Agenda
Planning Commission
Wednesday, 20 November 2019 – 7:00 P.M.
City Hall – Council Chambers, 1 S Huron St
Ypsilanti, MI 48197

**Staff Review of Site Plan Review
Octapharma Plasma
815 W Michigan Avenue**

Action Requested: Site Plan Approval

809-815 W. MICHIGAN AVE

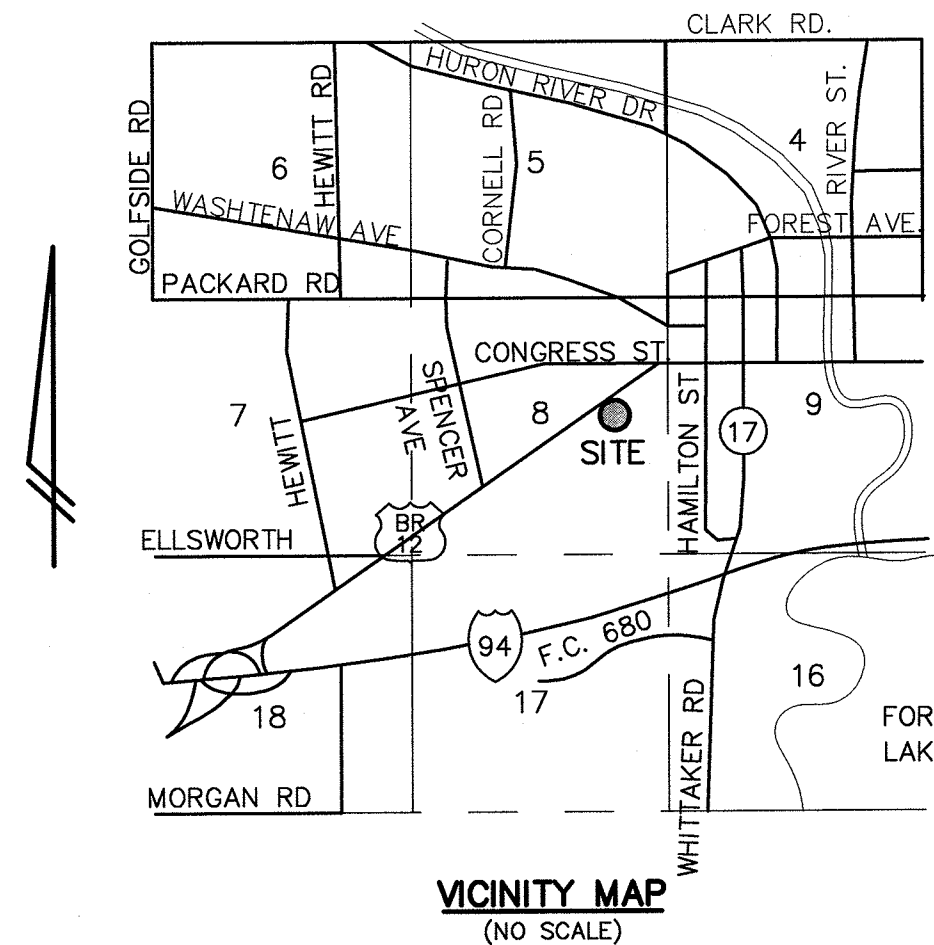
Items to be addressed: The existing site currently lacks any barrier free spaces staff recommends requiring at least 1 barrier free spot and would prefer to see 2 spaces made available. Staff recommends closing the easternmost upper level curb cut due to potential conflict with the new building. Rearrange remaining parking (entrance appropriately located opposite Summit) for flow and accessibility. Not all existing parking spaces have wheel stops and should be required to replace those missing. No Photometric Study exists for the entire site to determine sufficient lighting conditions. Staff recommends 2 landscaped islands be provided to comply with the requirement in §122-684 per the number of parking spaces on site. Staff recommends the addition of 5 new bicycle spaces to bring into compliance with 1 per 5 parking spaces standard. Staff recommends a truck turning plan for the deliveries taken in the upper lot. Rear parking screening must be a solid wall or fence constructed of face brick, poured-in-place simulated face brick, and precast brick face panels having simulated face brick, stone, or wood.

Items to be addressed: Applicant shall submit a photometric to ensure dark sky compliance. Applicant shall provide a plan for trash storage area. Applicant shall submit a landscaping plan and address street tree deficit of 13 trees and 2 landscaped islands. A chain fence exists in the rear parking lot but does not meet the opacity requirements listed in §122-634.

Staff recommends the Planning Commission **approve** the Site Plan for the Octapharma Plasma at approximately 815 W Michigan Ave with the following conditions:

3. Not all existing parking spaces have wheel stops and should be required to replace those missing.
4. No Photometric Study exists for the entire site to determine sufficient lighting conditions.

7. Staff recommends a truck turning plan for the deliveries taken in the upper lot.
8. Rear parking screening must be a solid wall or fence constructed of face brick, poured-in-place simulated face brick, and precast brick face panels having simulated face brick, stone, or wood.

9. Applicant shall submit a photometric to ensure dark sky compliance.
10. Applicant shall provide a plan for trash storage area.
11. Applicant shall submit a landscaping plan and address street tree deficit of 13 trees and 2 landscaped islands.

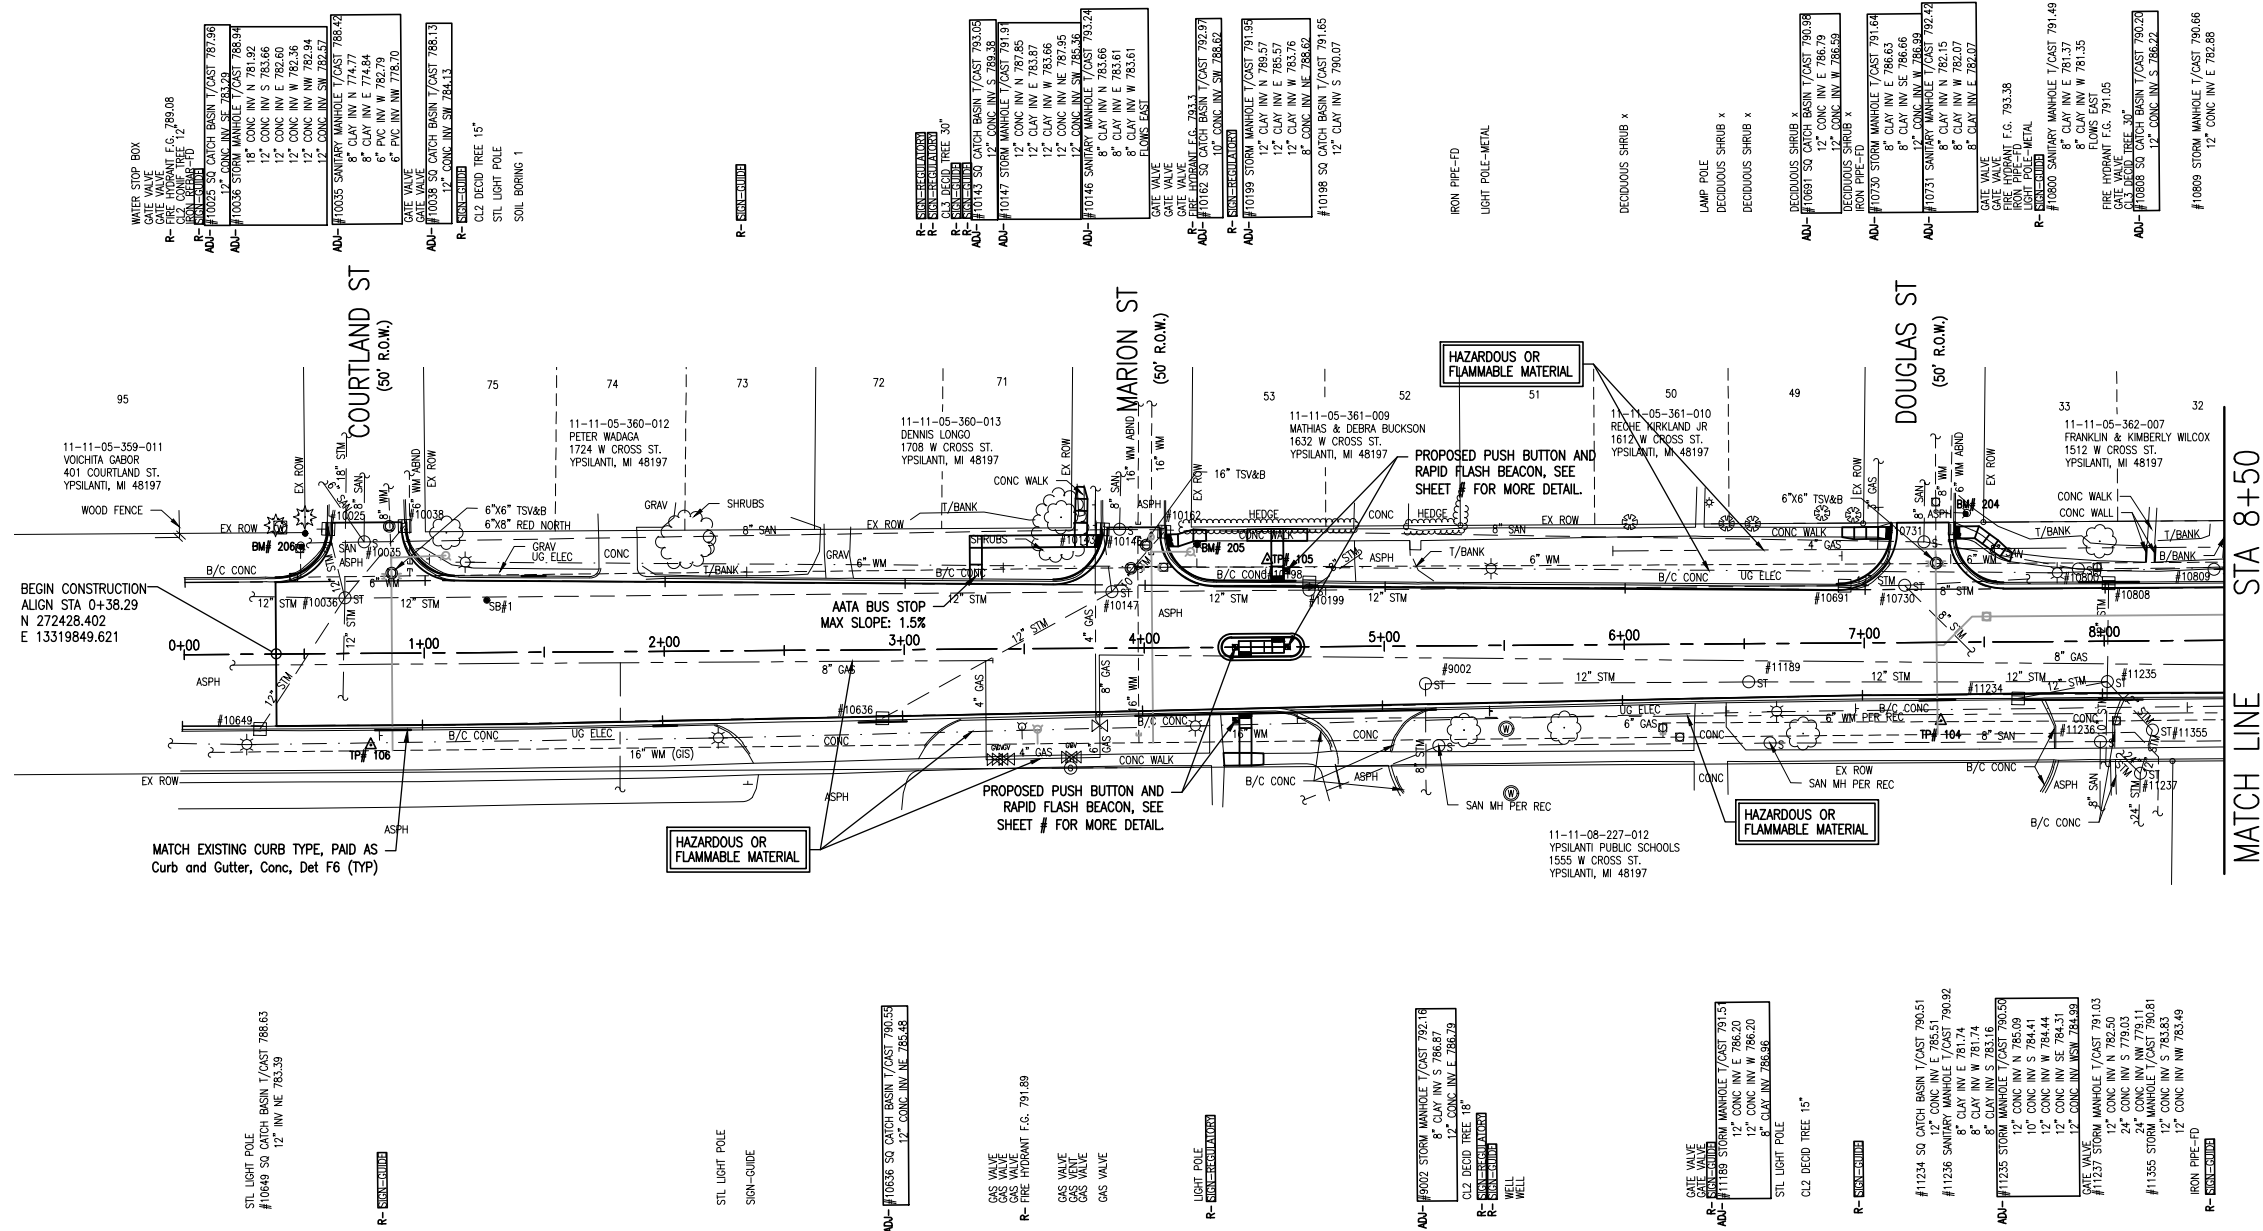
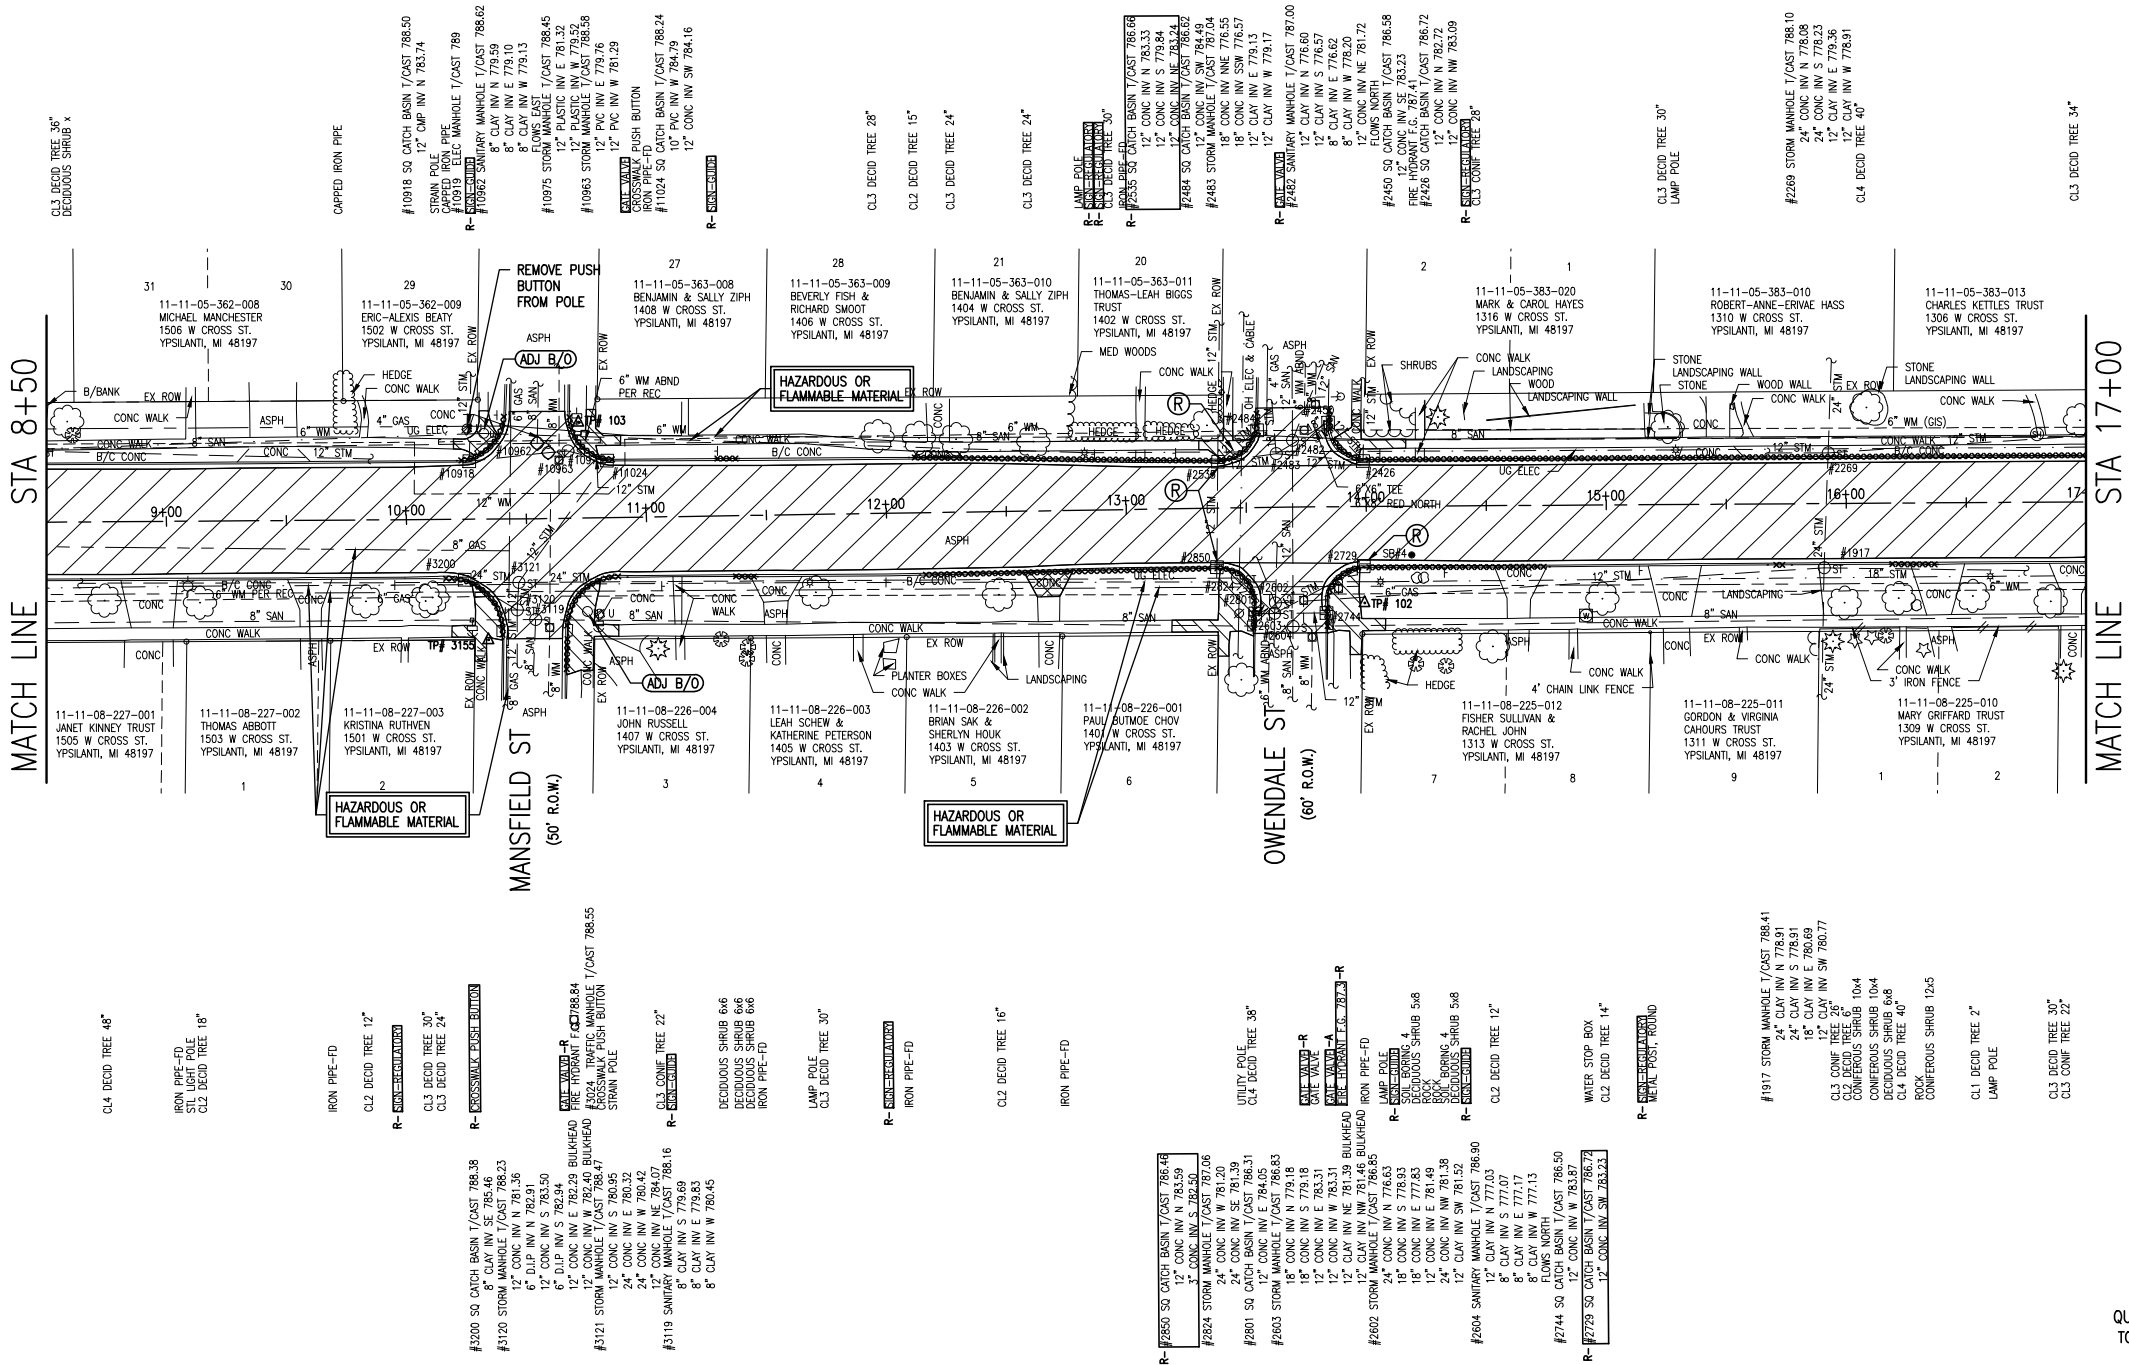
Due to the high travel speeds currently on Cross west of Mansfield, only one pedestrian crossing of Cross is proposed, at a new mid-block, rapid rectangular flashing beacon enabled crossing between Marion and Douglas. This would be the first RRFB in the City, but there are several throughout the County, including further west on this same street, just west of Carpenter. See Sheet 7.

A new pedestrian crossing of Marion, with sidewalk to the bus stop just west of this intersection, is provided; however, sidewalk is not provided for the full length of Cross between Courtland and Marion. See sheet 7.
